### **Amendments to the Drawings**

### **REMARKS**

FIG. 1a

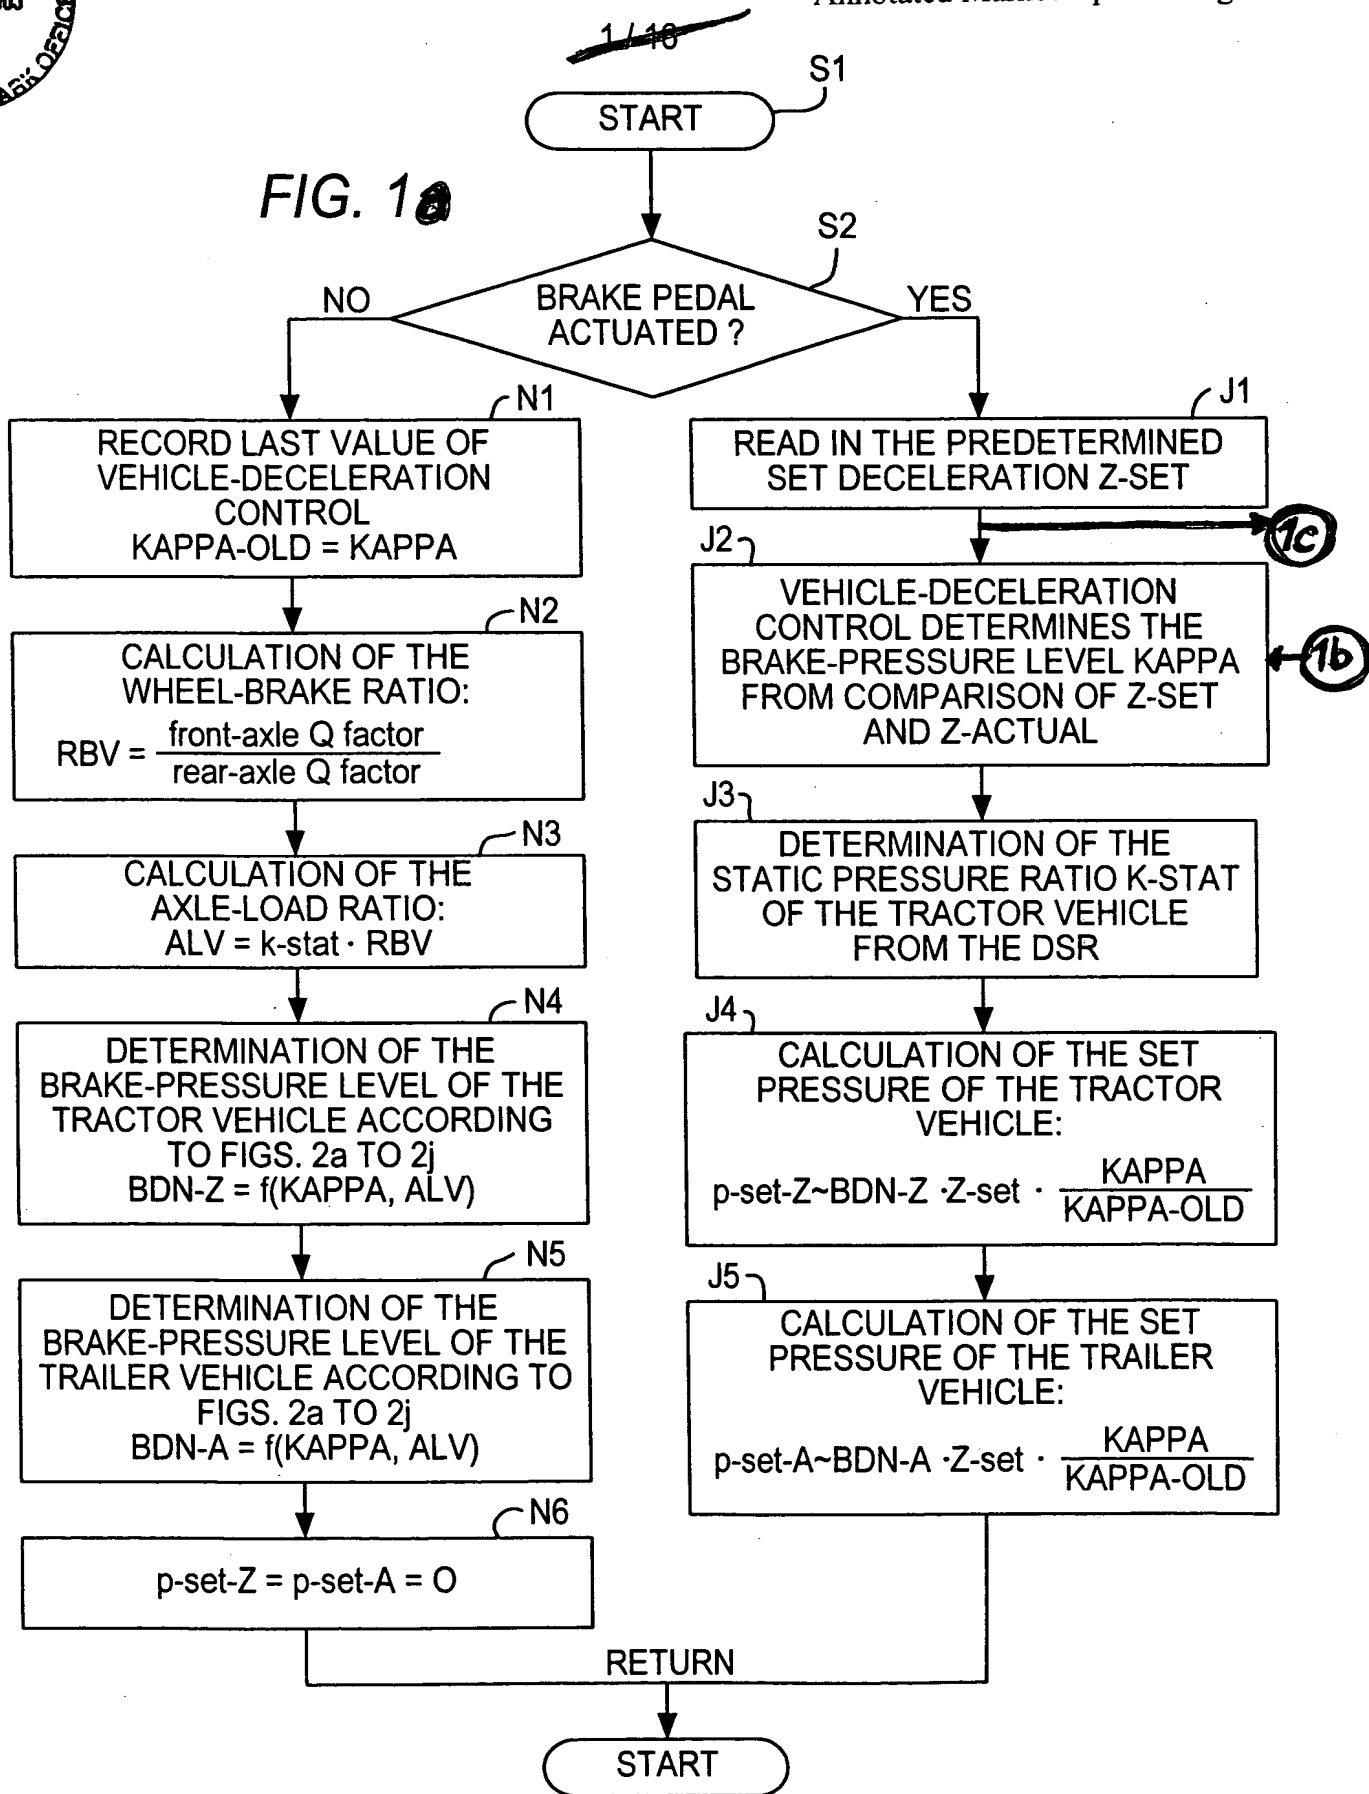
Applicants do not understand, and accordingly respectfully request that the Examiner clarify, the objection to the relationship depicted in block J5 of Fig. 1. As set forth in the application specification as filed (see paragraph [0035] of the published application, for example), this equation describes how the set brake-application energy value P-set-A can be calculated from the mathematical relationship  $BDN-A \cdot Z_{set} \cdot (\kappa/\kappa_{old})$ . Applicants respectfully submit that the equation speaks for itself.

Regarding the vehicle dynamics data, as depicted in the attached Replacement Sheets and Annotated Marked-Up Drawing Sheets, Applicants have added Fig. 1b which shows such data as well as vehicle combination mass as possible inputs to step J2 of Fig. 1. Applicants have also added Fig. 1c which shows a step J1a of filtering the brake-application energy reference value. Fig. 1 has been relabeled "Fig. 1a" to accommodate the addition of Fig. 1b as well as Fig. 1c.

FIG. 1b

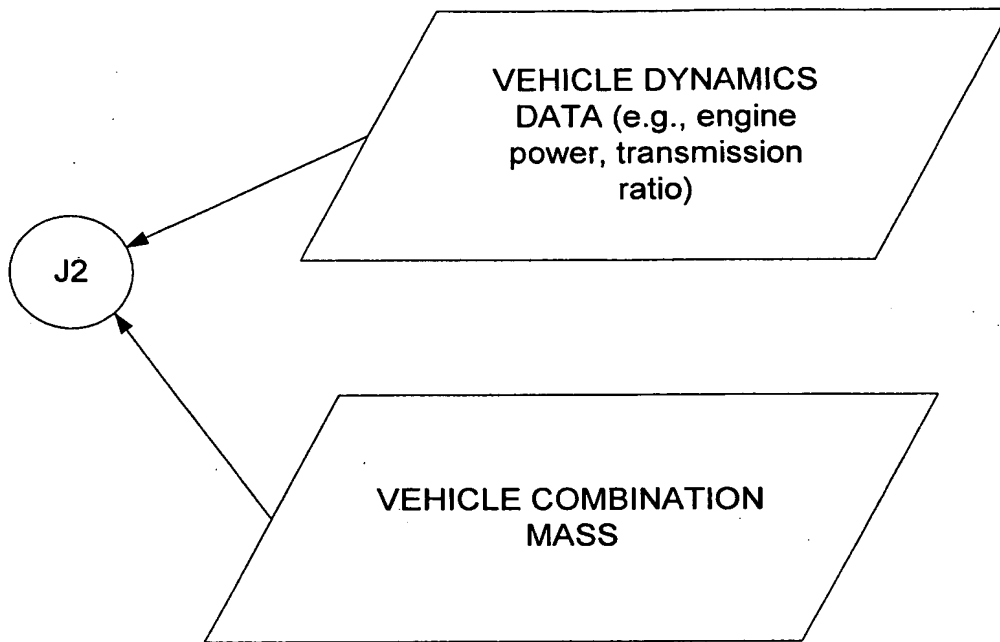
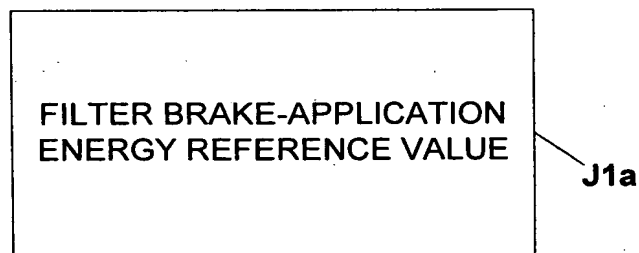
In the Office Action, the Examiner first objected to the drawings as not showing (i) the axle load sensors (or the means for determining axle load) as recited in claim 17, (ii) the vehicle dynamics data (including engine power and transmission ratio) as recited in claim 23, (iii) the means for enabling the filtering of the brake application energy reference value as recited in claim 24, (iv) the means for measuring actual deceleration as recited in claim 28, (v) the electronic braking system recited in claim 1, and (vi) the elements recited in claim 5. The

FIG. 2d

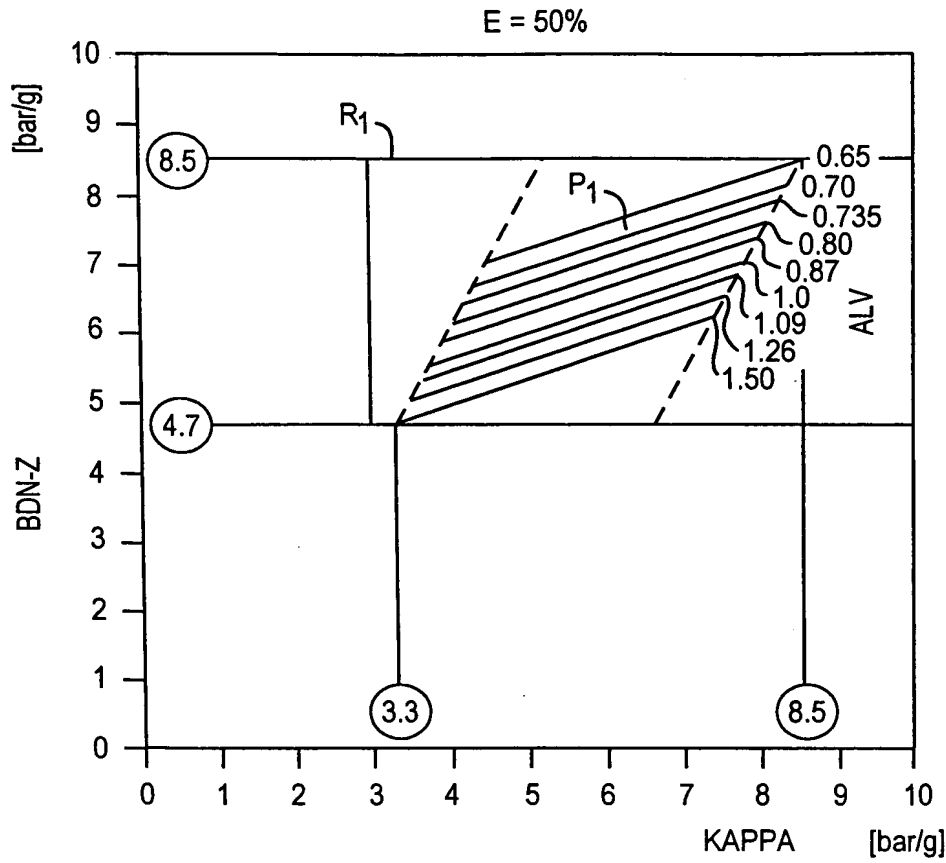
The Examiner further objected to the drawings because the x-axes of the graphs depicted in Figs. 2b, 2d, 2f, 2h and 2j are not separately labeled. As depicted in the attached Replacement Sheets and Annotated Marked-Up Drawing Sheets, Applicants have added the label “KAPPA [bar/g]” to each of these graphs.

The label “KAPPA [bar/g]” has been added to the x-axes of the graphs depicted in Figs. 2b, 2d, 2f, 2h and 2j. Elements Z, AA-1, AA-2 and AA have been deleted from Fig. 3a. Original Fig. 1 has been relabeled “Fig. 1a” and references to new Figs. 1b and 1c have been added to accommodate new Figs. 1b and 1c. New Fig. 1b shows data inputs to step J2 of Fig. 1a; new Fig. 1c shows a step J1a of filtering the brake-application energy reference value. New Fig. 9 is a simplified schematic diagram of a tractor vehicle (and partial view of a trailer vehicle) of a conventional tractor-trailer vehicle combination showing an EBS and including an EBS control unit 10 (which includes the capability of effecting filtering of the brake application energy reference value) and means for determining actual deceleration 20, a brake pedal 30, including a signal transmitter for desired brake values 40, brake actuators 50, 60 for the front and rear axles, respectively, wheel speed sensors 70, 80 and axle load sensors 90, 100.

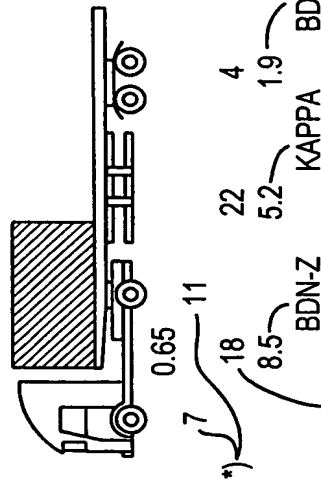
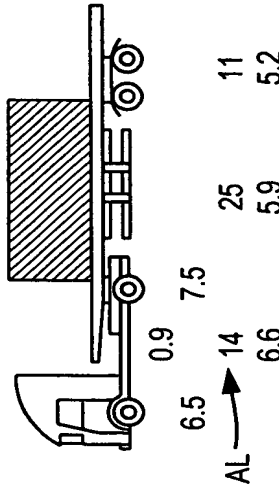
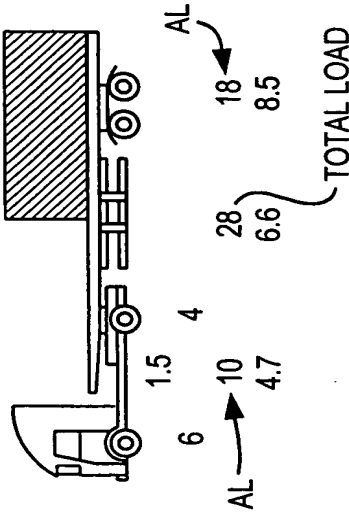
The Examiner additionally objected to Figs. 3a-3e, 4a-4c, 5a-5i, 6a-6e and 7a-7e of the drawings in their inclusion of “unlabeled numbers.” Applicants note that the position of each number in the various arrays of numbers set forth in the drawings below the depictions of the tractor-trailer vehicle indicates the value for which each number stands (whether axle load or KAPPA or other value). Applicants respectfully submit that the numbers are clearly labeled by their position throughout the drawings as a whole (see e.g., Figs. 3b, 3e, 4a and 5c), and that, accordingly, when the drawings are considered as a whole, there are, for all intents and purposes, no “unlabeled numbers.” Furthermore, the values associated with the various specific numbers are discussed throughout the application specification as filed. For example, the Examiner is referred to paragraphs [0044] and [0047] of the published application.

In view of the foregoing, Applicants respectfully submit that Figs. 3a-3e, 4a-4c, 5a-5i, 6a-6e and 7a-7e of the drawings are in compliance with 37 CFR 1.84(p)(5). Notice to this effect is respectfully requested.

FIG. 9

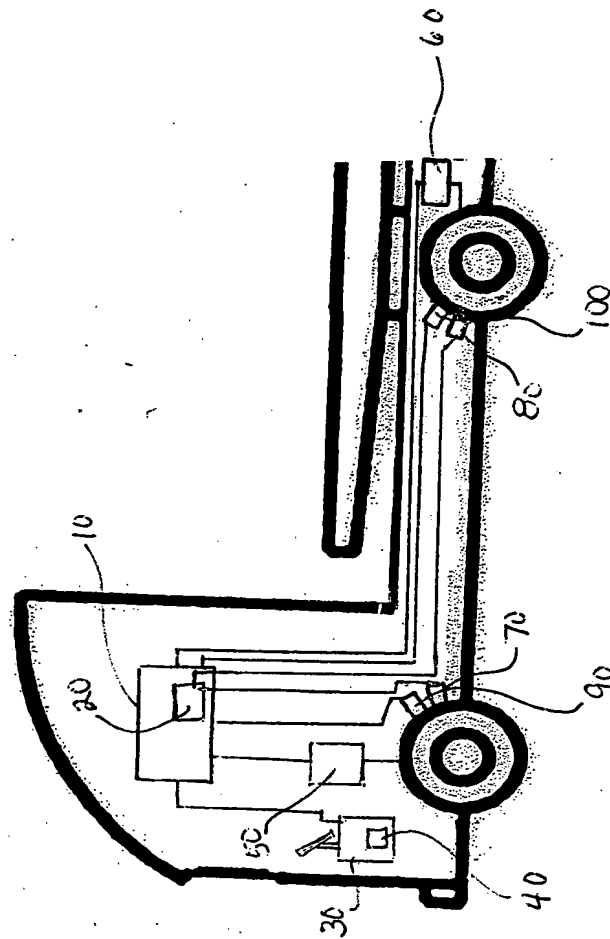
Examiner required that the foregoing features either be shown in the drawing figures or deleted from the claims.

To address the Examiner's concerns and promote the application to early allowance, as depicted in the attached Replacement Sheets and Annotated Marked-Up Drawing Sheets, Applicants have added new Fig. 9 to the drawings which is a simplified schematic diagram of a tractor vehicle (and partial view of a trailer vehicle) of a conventional tractor-trailer vehicle combination showing an EBS and including an EBS control unit 10 (which includes the capability of effecting filtering of the brake application energy reference value) and means for determining actual deceleration 20, a brake pedal 30, including a signal transmitter for desired brake values 40, brake actuators 50, 60 for the front and rear axles, respectively, wheel speed sensors 70, 80 and axle load sensors 90, 100. As these elements are conventional, they are shown as "black box" labeled representations.

Support for the addition of new Fig. 9 resides in at least the claims noted by the Examiner in the drawing objection. Accordingly, no new matter has been introduced.
